Re: Manor Pickleball Courts Phase II
Aberdeen, South Dakota
A-8381

ADDENDUM NUMBER 1

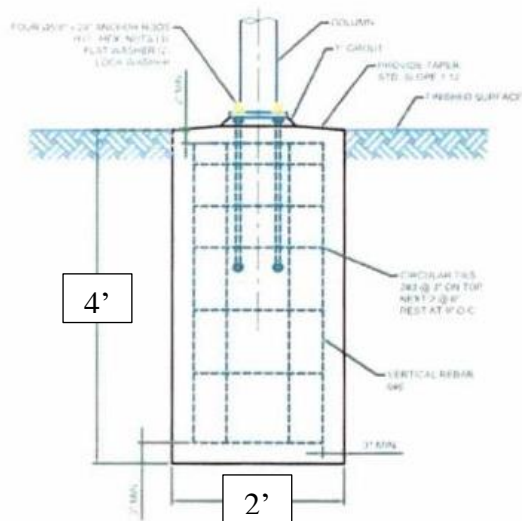
2. BIDDING CLARIFICATION, ITEM 3 “Unclassified Excavation”- *This shall include the removal of the tree stump shown on page 2 of the plans.*

Figure # 2

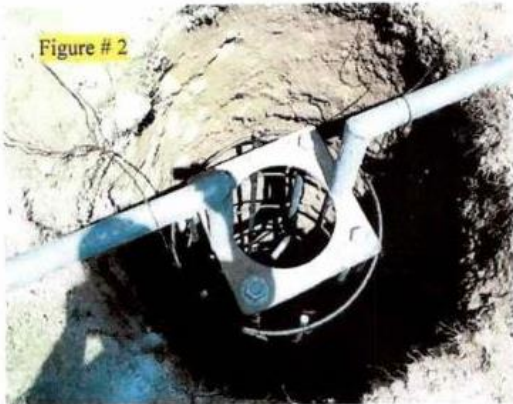
5. PLANS, PAGE 7- *Insert this detail for the Umbrella Foundations.*

These footings are designed specifically for a 20’ diameter Coolbrella Model 102.3 and are not valid for any other model. These are engineered for 60 MPH winds maximum.

- Surface-Mounted or Recessed Plate Columns will require you to make a template the same pattern as the base plate on the column for holding the anchor bolts while pouring concrete. **See figure # 2**
